80960SA/SB SPECIFICATION UPDATE

Release Date: June, 1997
Order Number: 272850-002

The 80960SA/SB may contain design defects or errors known as errata which may cause the 80960SA/SB to deviate from published specifications. Current characterized errata are documented in this Specification Update.

Figure 1. Block Diagram of Workaround

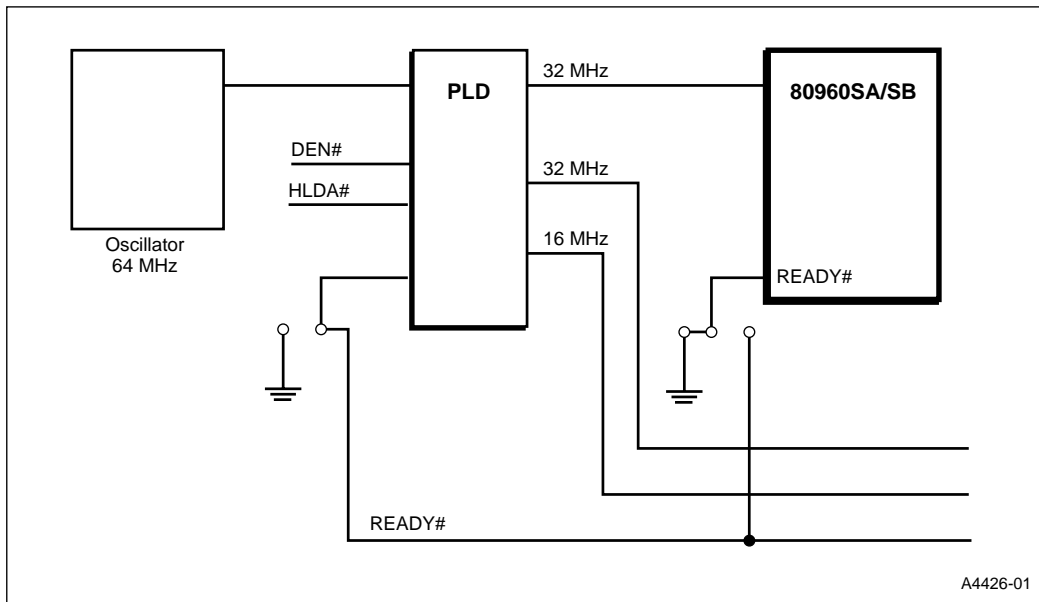
PROBLEM: During many accesses with wait states, the BE1:0# signals incorrectly switch after the first Tw state. The affected accesses include:

- All byte accesses with wait states.
- All quad-word, triple-word, long-word, word or short-word accesses with single-byte misalignment and wait states.

If the bus cycle is a burst access, the problem occurs on each data transfer within the burst. This problem will not occur if READY# always goes active early enough to signal zero wait states.

WORKAROUND: Do not use the READY# input; tie it to a LOW logic state. If wait states are necessary, gate the input clock using external logic.

Figure 1 illustrates example workaround logic. A programmable logic device (PLD) driven by a 4X clock oscillator provides a 2X clock for the 80960SA/SB and other system clocks. READY# is an input to the PLD which stops the 2X clock whenever it is asserted. When READY# is deasserted, the PLD resynchronizes the 2X clock to the system clocks. Figure 2 is a state diagram of the workaround.

The 80960SA/SB has dynamic registers, so do not stop its input clock for more than about one microsecond. This restriction limits the number of wait states to about nine for a 10 MHz 80960SA/SB.
